The EAO's Assessment of a Request for Non-Material Amendment

Murray River Coal Project
EA Certificate #M15-03

Requested by:
HD Mining International Ltd

March 23, 2018

Figure 2: Proposed Changes to the Murray River Coal Project

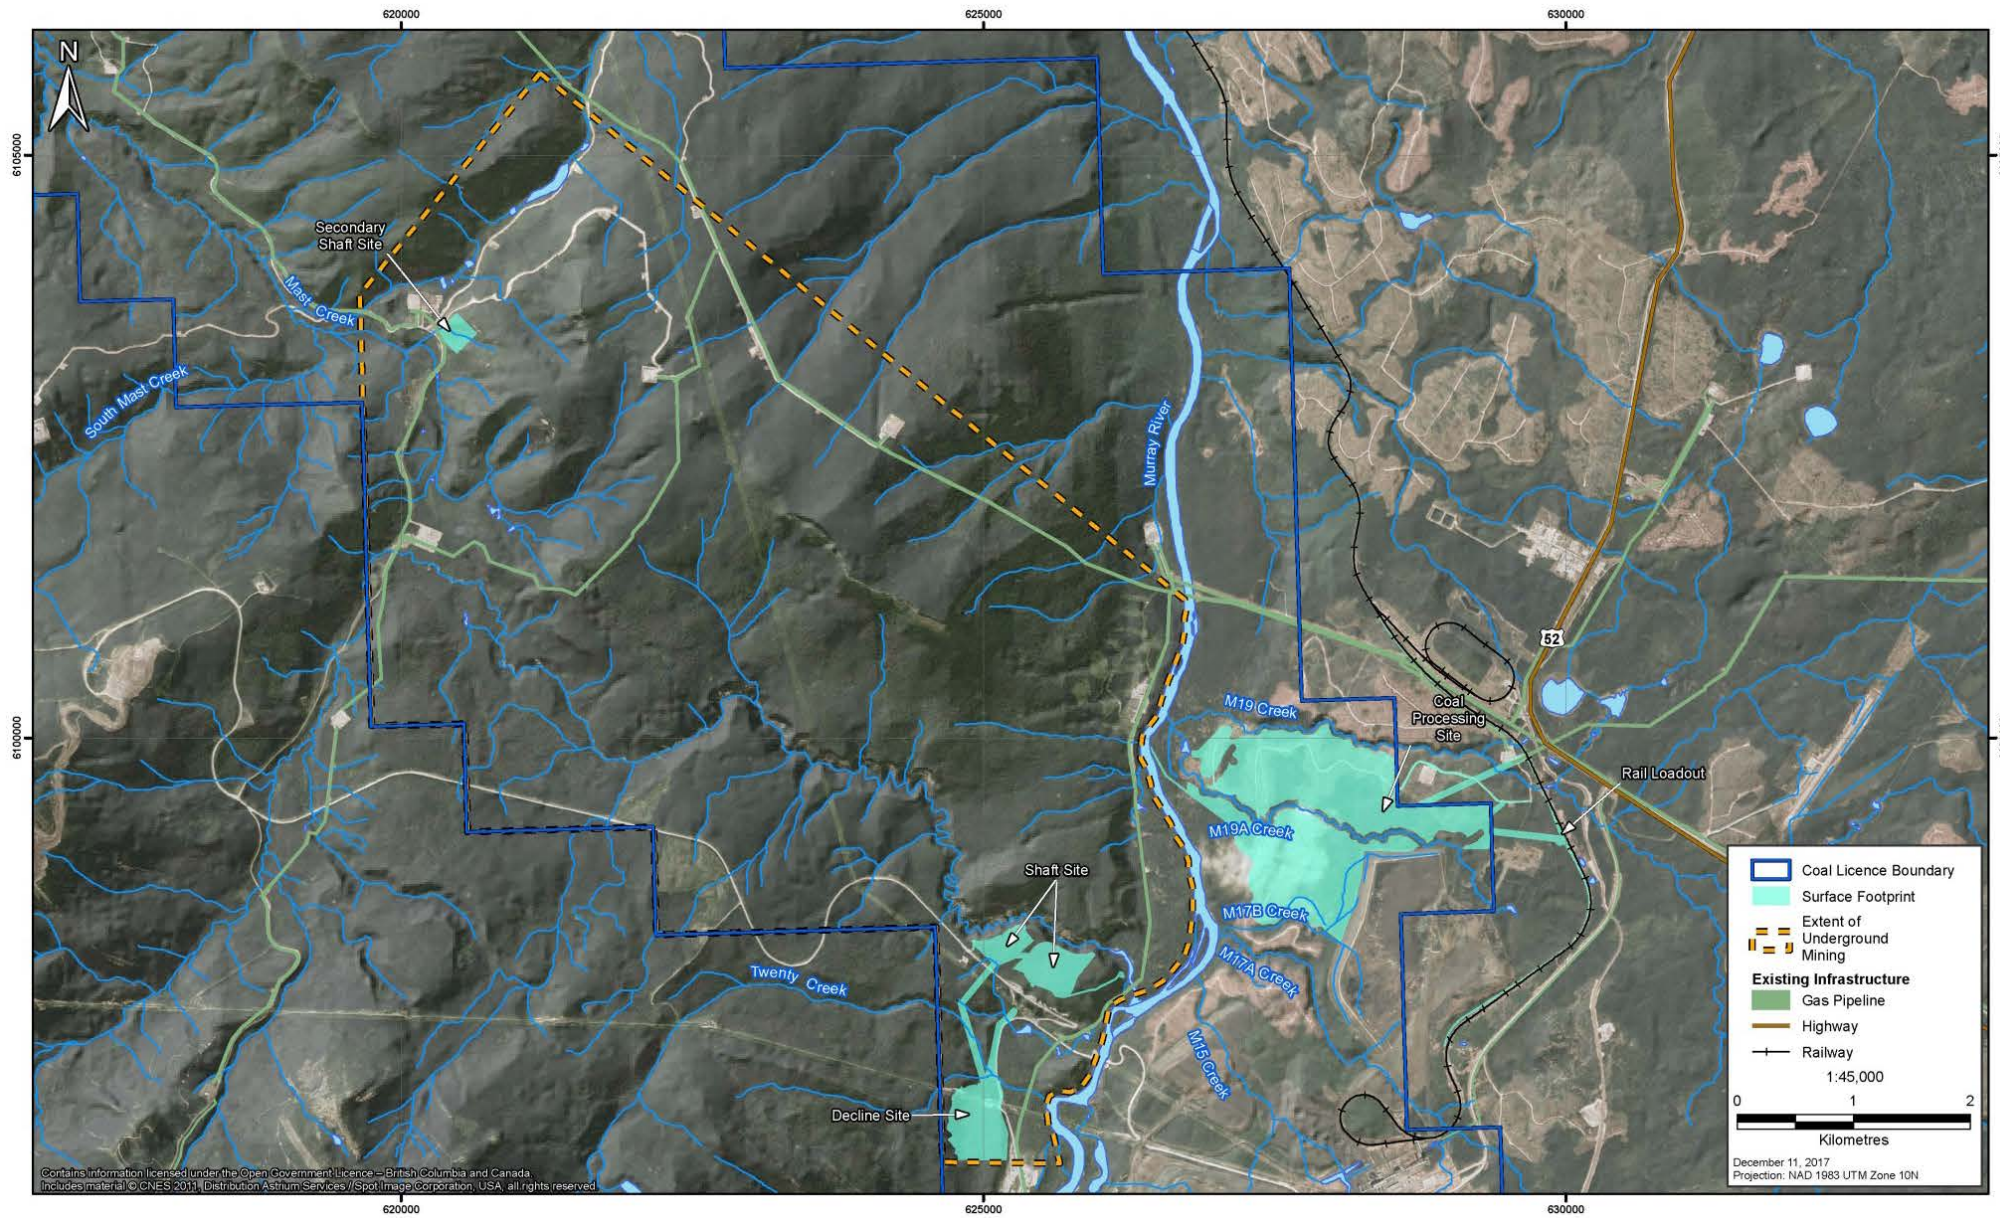
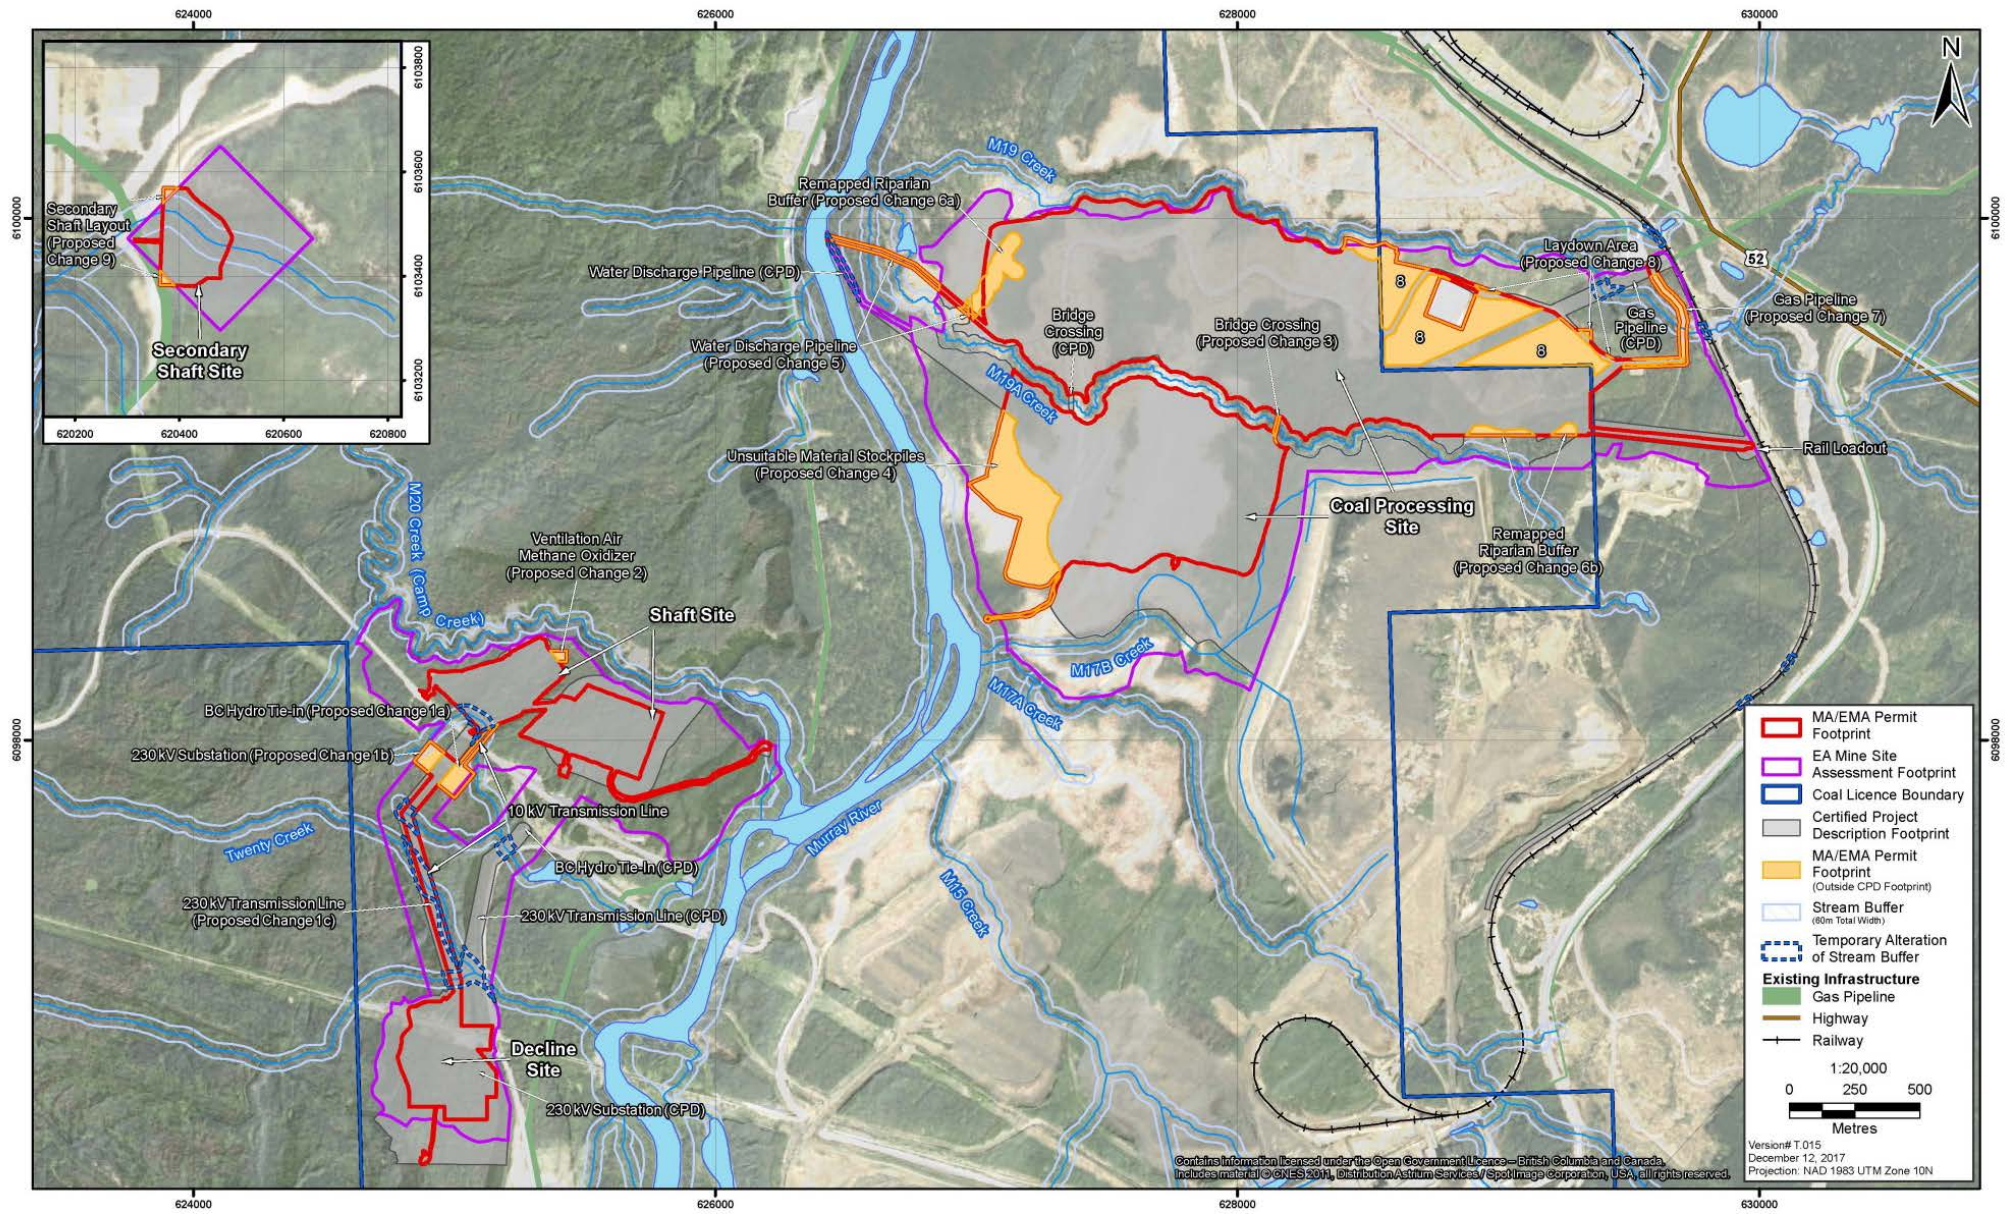
On December 12, 2017, HD Mining submitted a memorandum to the Environmental Assessment Office (EAO) outlining nine (9) proposed changes to the project (see Table 1 and Figures 1 and 2). HD Mining requested a determination on the materiality of the proposed changes, and requested that the Certified Project Description (CPD) of the EAC be amended to include these changes if they are determined to be not material in nature. The full text of HD Mining’s request for non-material amendment and an accompanying memo is posted on the EAO Project Information and Collaboration (EPIC) website at <https://projects.eao.gov.bc.ca/p/murray-river-coal/docs?folder=51>.

Proposed Change	Description
1: Relocation of 230 kV transmission line and tie-ins to the BC Hydro grid and substation	Install the 230 kV transmission line (including the BC Hydro tie-in and substation) in the same corridor as the 10 kV transmission line
2: Addition of VAM oxidizer for methane management	Include a VAM oxidizer in the surface infrastructure for the management of methane emissions
3: Relocation of M19A Creek Crossing	Relocate the planned bridge crossing over the M19 Creek closer to the coal preparation plant

Proposed Change	Description
4: Additional Unsuitable Material Stockpiles	Add additional unsuitable stockpiles to planned overburden and soil storage areas
5: Realignment of Water Discharge Pipeline	Realign the water discharge pipeline to accommodate additional unsuitable material stockpiles
6: Remapping of M19A Creek Riparian Buffer	Remap M19A riparian buffer to align with site-specific knowledge of streamlines
7: Realignment of Gas Pipeline	Realign the natural gas pipeline to follow the access road to the mine site
8: Addition of Laydown Area	Add a laydown area to stage and organize building materials, equipment, and personnel
9: Change to Secondary Shaft Layout	Request withdrawn in subsequent clarification memorandum

The project design that was submitted as part of HD Mining’s applications for MA/EMA permits differs slightly from the CPD contained in Schedule A of the EAC (as shown on Figure 1). The request for a non-material amendment identifies proposed changes to the CPD that, if approved, would align with the project design described in the proposed MA/EMA permits (as shown on Figure 2).

The EAO has assessed the materiality of each of the eight proposed changes to the Project considering the factors outlined in Section 7(2) of the EAC and it is the EAO's view that the proposed changes are not material in nature.

The EAO recommends that Schedule A of EAC #M15-03 be amended under Section 19(3) of the Act to include the eight proposed changes.
